Agenda Item # 1 - HOLDOVER

SUB-002777-2023

The Hive Subdivision

THE HIVE SUBDIVISION

SITE PLAN

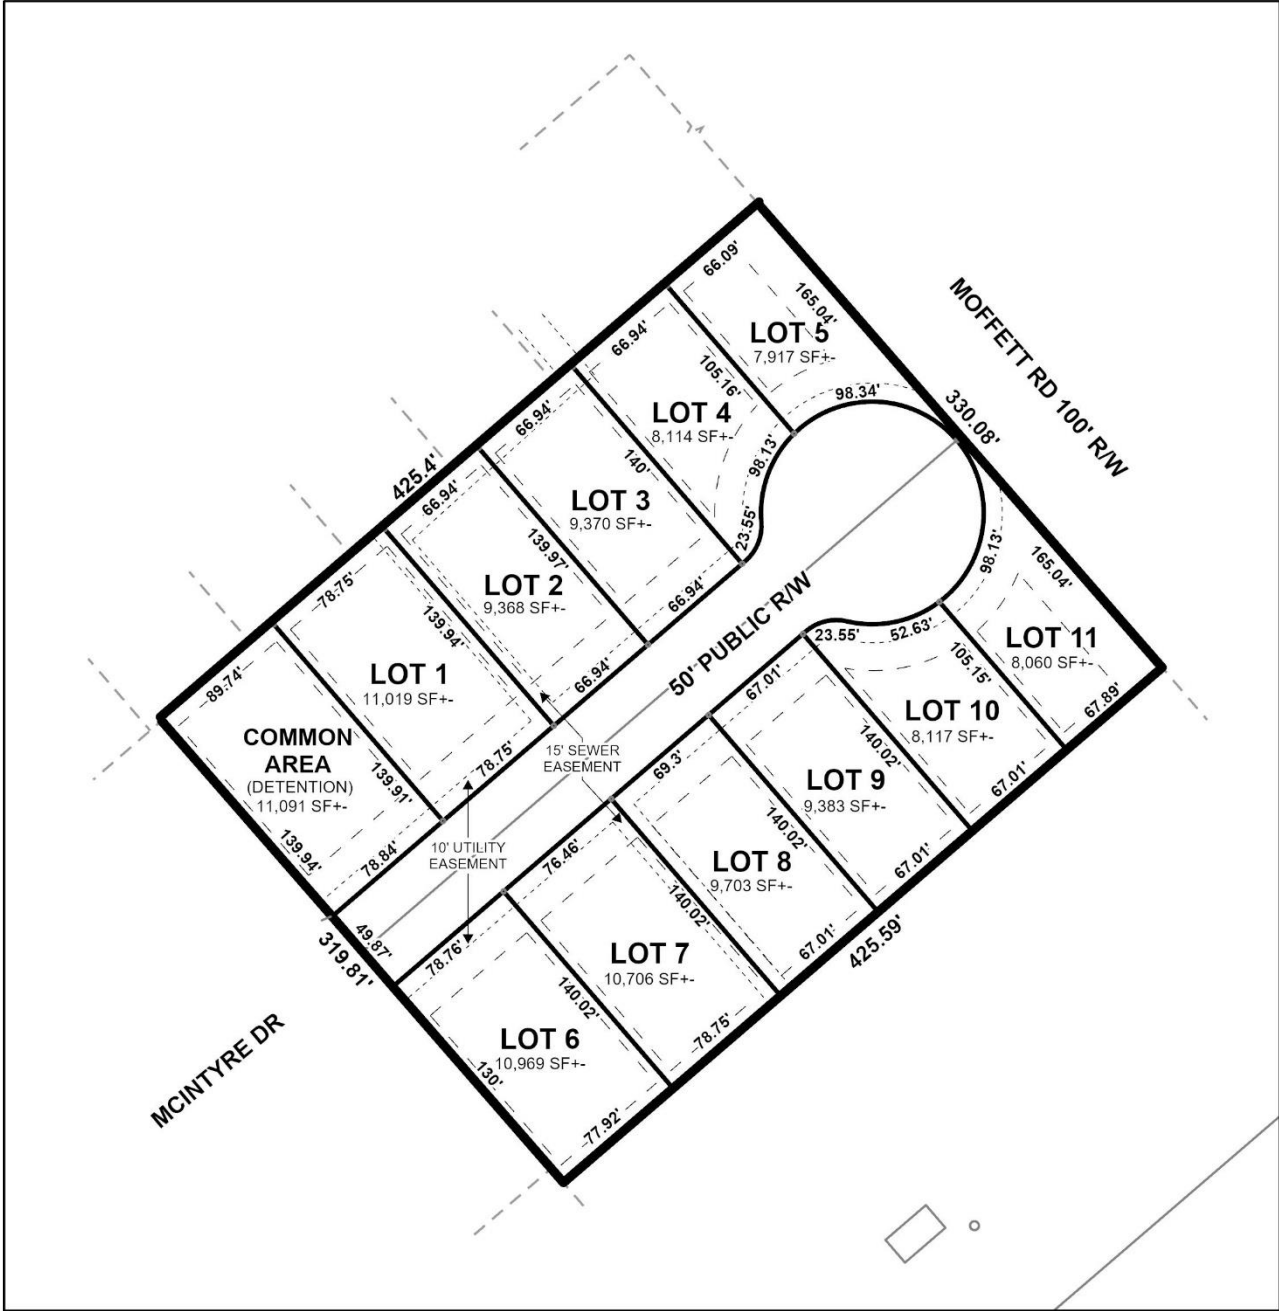
The site has frontage on Moffett Road, a Principal Arterial road requiring a 100-foot right-of-way, which is adequately depicted on the preliminary plat. If approved, this information should be retained on the Final Plat.

The site also has frontage along the East terminus of McIntyre Drive, a minor street with curb and gutter requiring a 50-foot right-of-way. A closed-end extension of this street is proposed as part of this request, and is depicted on the preliminary plat with a compliant 50-foot public right-of-way. A turnaround is illustrated where McIntyre Drive will end, in compliance with Section 6.B.3 of the Subdivision Regulations, but its diameter is not provided. For a closed-end street the right-of-way diameters are determined by the City Engineer and must comply with the most recently adopted International Fire Code (IFC). If approved, the plat should be revised to depict the right-of-way diameter of the turnaround, as approved by both the Traffic and City Engineer. The 50-foot right-of-way for the remainder of McIntyre Drive should be retained on the Final Plat, if approved.

The Preliminary Plat illustrates utility and sewer easements. If approved, a note should be required on the Final Plat stating that no structure may be constructed or placed within any easement without the permission of the easement holder.

The 25-foot minimum setback is illustrated along the proposed McIntyre Drive extension, and along Moffett Road, in compliance with Section 64-2.5 of the UDC, but it is not labeled. Revision of the plat to label the 25-foot minimum setback should be required, if approved.

It should be noted that double-frontage lots are discouraged by Section 6.C.7. of the Subdivision Regulations. However, the proposed double-frontage is a common lot configuration for subdivisions that "back up" to major streets; as such, a waiver of Section 6.C.7. may be appropriate. If approved, a note should be placed on the Final Plat stating that Lot 5 and Lot 11 are denied access to Moffett Road.

With regard to setbacks, per Article 2 Section 64-2-5 of the Unified Development Code, a 25-foot front yard setback, 5-foot side yard setbacks, and 8-foot rear yard setbacks are required for lots in an R-1, Single-Family Residential Suburban District. Additionally, per Section 6.C.8. of the Subdivision Regulations, only a front yard setback is required to be illustrated on a Final Plat. Though not labeled with specific measurements, the Preliminary Plat illustrates a minimum setback which appears to be greater than what is required by the Unified Development Code. The applicant may retain setbacks as illustrated, with the addition of setback labels, but if approved and the plat recorded in the Mobile County Probate Court depicts the setbacks as illustrated, future development of the properties will be subject to setbacks greater than what are required by the UDC. As such, only the 25-foot front yard setback should be illustrated along McIntyre Drive and Moffett Road, and no side or rear setbacks should be illustrated on the Final Plat.

The lot sizes are provided in both square feet and acres on the preliminary plat and exceed the minimum size requirements of Article 2, Section 64-2.5.E. of the UDC for lots served by public water and sanitary sewer in an R-

As proposed, the site includes "Common Area" to be utilized for stormwater detention. If approved, a note should be placed on the Final Plat stating that the maintenance of Common Areas shall be the responsibility of the property owners, and not the City of Mobile.

1. Retention of all right-of-way widths as depicted on the preliminary plat;
2. Revision of the plat to depict an adequate turnaround diameter where the street will terminate, with the design approved by the Traffic Engineer and City Engineer;

3. Retention of the lot sizes in both square feet and acres, or the furnishing of a table on the Final Plat providing the same information;
4. Revision of the Final Plat to illustrate at least a 25-foot front yard setback along McIntyre Drive and Moffett Road;

5. Removal of side and rear setbacks from the Final Plat;
6. Placement of a note on the Final Plat stating that maintenance of the Common Area shall be the responsibility of the property owners and not the City of Mobile;

7. Placement of a note on the Final Plat stating that no structure may be constructed or placed within any easement without the permission of the easement holder;

8. Compliance with all Engineering comments noted in this staff report;
9. Placement of a note on the Final Plat stating all Traffic Engineering comments noted in this staff report;

10. Compliance with all Urban Forestry comments noted in this staff report; and,
11. Compliance with all Fire Department comments noted in this staff report.
